MODIFICATION INSTRUCTIONS

ENGINEERING CHANGE NOTICE

ECN # 978

EFFECTIVE DATE	ASSEMBLY	PART NUMBER	DRAWING NUMBER	REV
8-24-81	CPU BOARD	800-0107	800-0107	E

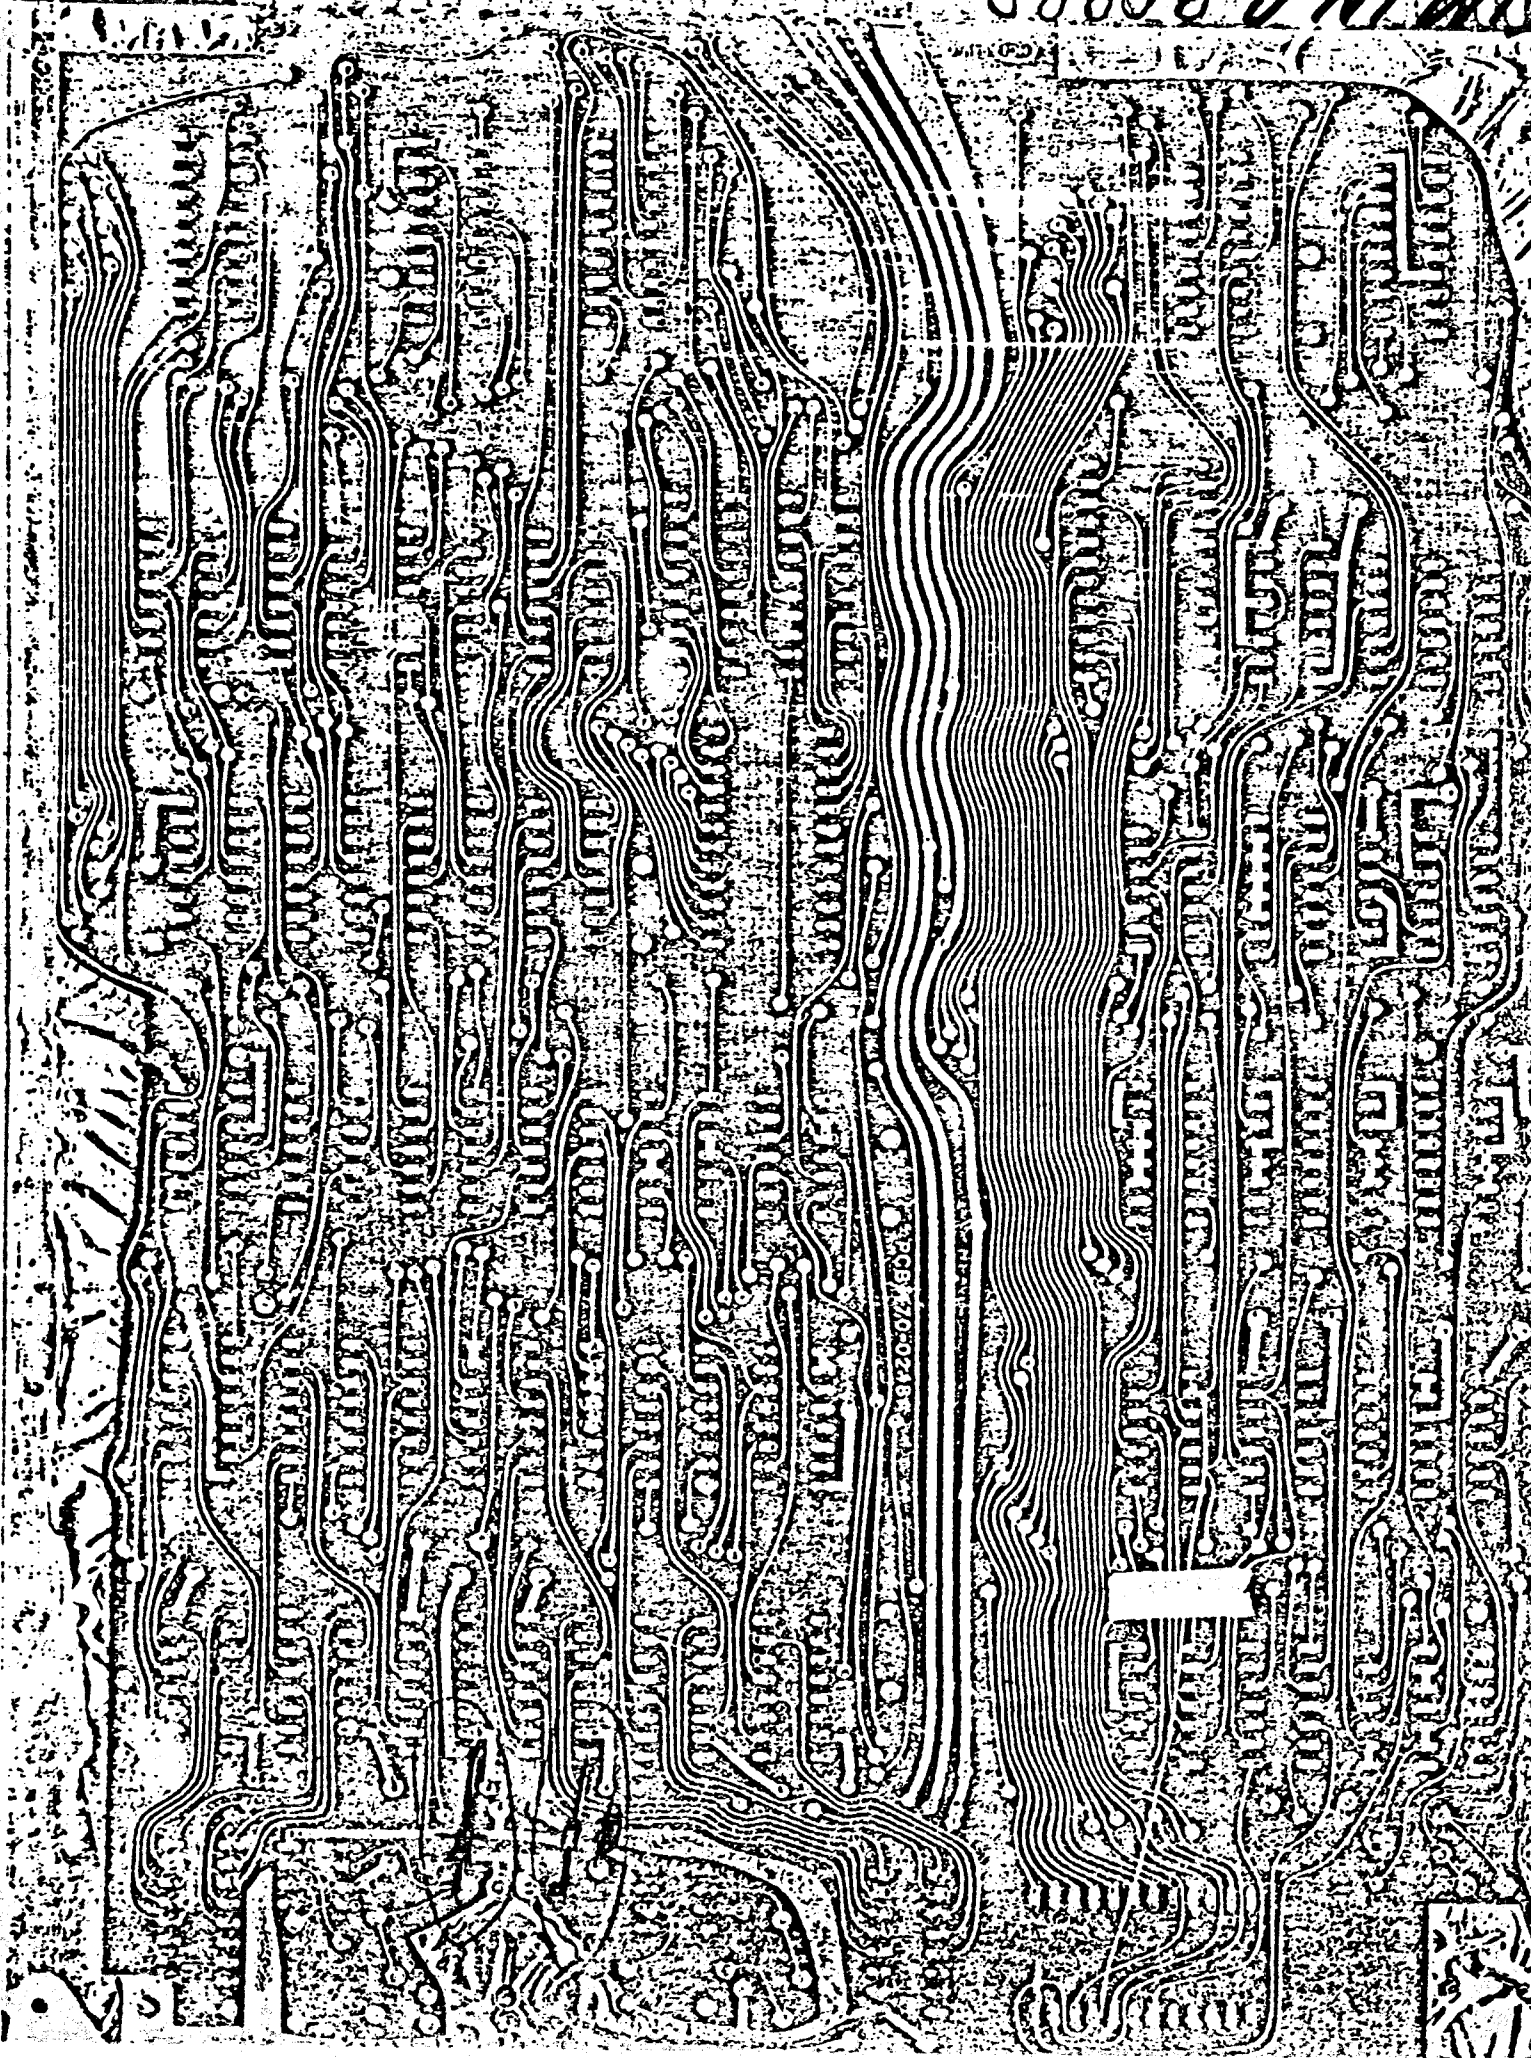
CHANGE SHEET 6 ZONE 7A:

IS: $\frac{1}{\text{---}}$ C45
.22UF
16V

WAS: $\frac{1}{\text{---}}$ C45
10UF
25V

REDUCE POWER ON DELAY FROM 1.5 SECS TO 20 MSECS
TO ALLOW XV MONITOR OUTPUTS TO BE RESET IN 20
MSECS THEREBY REDUCING STRESS ON MONITOR
OUTPUT CIRCUITS
